## SERVICE BULLETIN

No	
	lact ALL ELECTRONIC FLIPPERS
Effective	IMMEDIATELY
то:	SERVICE/PARTS MANAGERS

ASE1587-101 FLIPPER UNIT

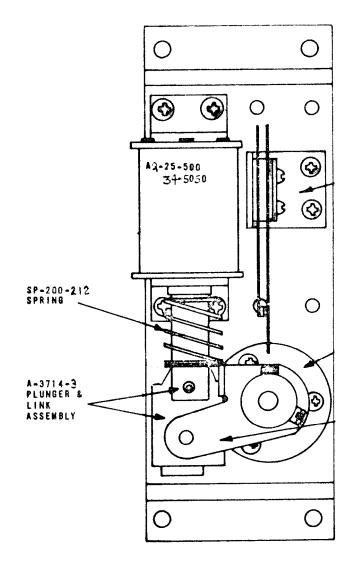
A. Attached is an assembly drawing of a BALLY electronic flipper. It shows two new assemblies: the SP-200-212 spring and the A3714-3 plunger and link assembly.

These are designed to  $\underline{\text{REPLACE}}$  the  $\underline{\text{SP200-211}}$  spring and the  $\underline{\text{A3714-2}}$  plunger and link assembly.

The addition of these components is the recommended method for correcting flipper hang-up on some electronic games.
